# Lightning Protection Systems

## ATLAS Enquiry Cases

The following enquiry cases have been received by the ATLAS Lightning Protection Committee regarding the interpretation of BS EN 62305, the recognised British Standard for the design, installation and testing of lightning protection systems.

## Ref. 06: Ridge Conductor (4 December 2009)

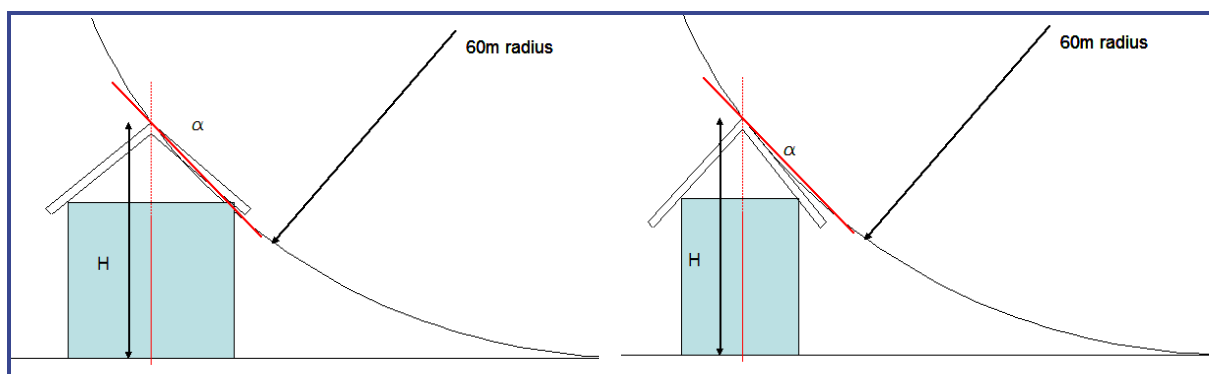
Will a ridge conductor offer protection over the eaves of a pitched roof?

There are three methods of providing protection: the mesh method, the protective angle method and the rolling sphere method. One or a combination of these can be applied to the design process. In this case, the protective angle method would be applied on its own. The designer would need to look at the reference plane on relation to the ridge conductor and carry out the assessment as per Part 3 Table 2.

E.14, 15 and 16 show various scenarios using the protective angle method on pitched roofs but does not appear to offer an example using just a ridge conductor. However ignoring the fact we have an eave at all, the angle of protection will apply in all cases (see below).

The area under the zone of protection is the same with or without the eave, with respect to the rolling sphere we can see in the above example how it may also offer protection to the eaves. The above example also shows a shallower pitch where eaves protection would be needed.

## Ref. 22: Use of Re-bars in Structural Reinforcing as the Down Conductor (29 August 2013)

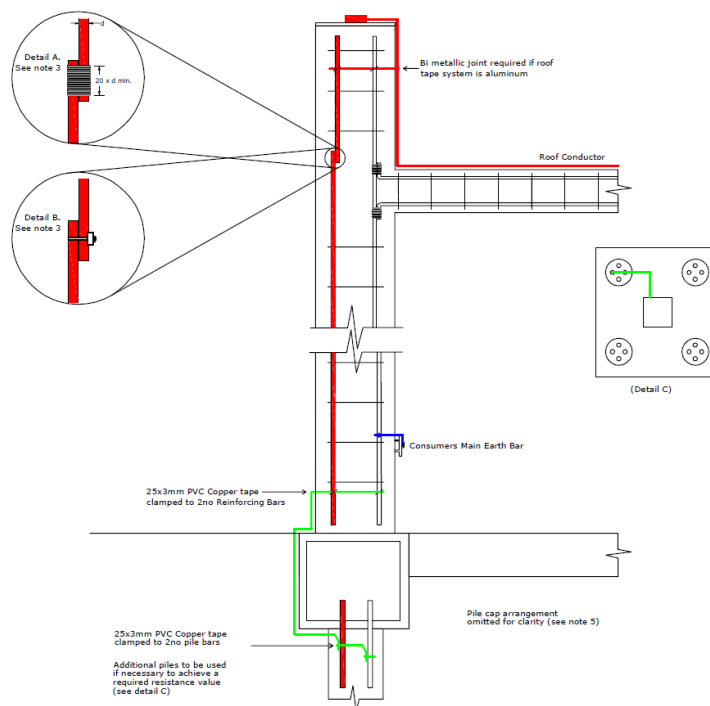
When utilising the cast in-situ structural reinforcing as the down conductor, please clarify the method, type and quantity of the connections to, and between, the re-bars.

BS EN 62305-3:2011 E.4.3.3 defines the method, dimensions and quantity of connection methods.

For the purpose of carrying lightning current, the available options to provide electrical continuity in a re-bar are illustrated in BS EN 62305-3:2011 Figure E.5 and are defined as;

1. Welded connections (with a minimum weld length of 50 mm)
2. Clamped connections (with components conforming to IEC/BS EN 65265-1)
3. Bound joints (overlapped 20 times the rebar diameter and fully bound along this length)

Lashed joints (simple twisted wire ties) are only considered suitable for EMC purposes i.e. not for carrying lightning current.

For connections to and from the re-bar at, say, roof and ground level there shall be two conductors connecting to different re-bars or one conductor extended to connect to two different re-bars.
